Staff Report

Report To: COW - Operations, Planning and Building Services
Meeting Date: February 4, 2025
Report Number: OPS.25.004
Title: Bay Street East Reconstruction PIC 2 Follow-up
Prepared by: Mike Humphries, Senior Infrastructure Capital Project Coordinator

Mill St. Sanitary Pumping Station and Bay Street Reconstruction

Re: Bay Street East Reconstruction Project - Public Information Centre #2

■ Infrastructure Depth

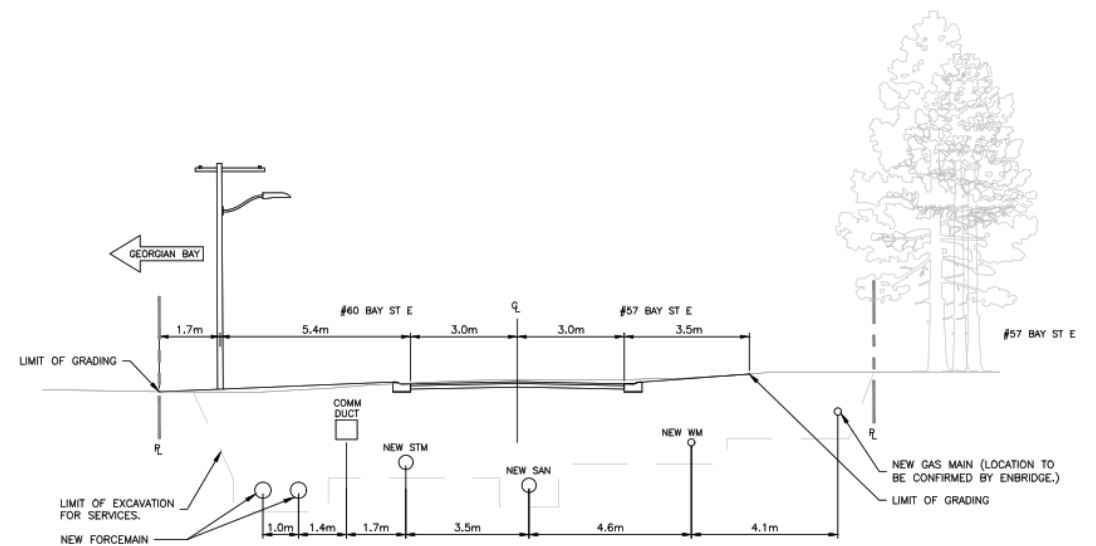
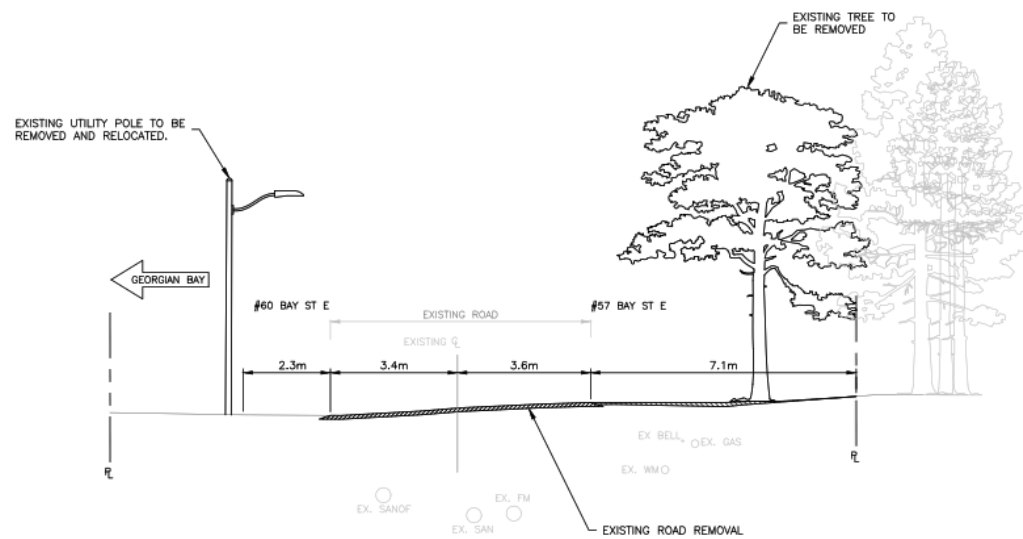
- Some comments have indicated sewer/forcemain depths of 10 m (30 ft).
- The deepest infrastructure will be at Mill St. end for pumping station. Most utilities will be less than 4 m (12 ft) deep.
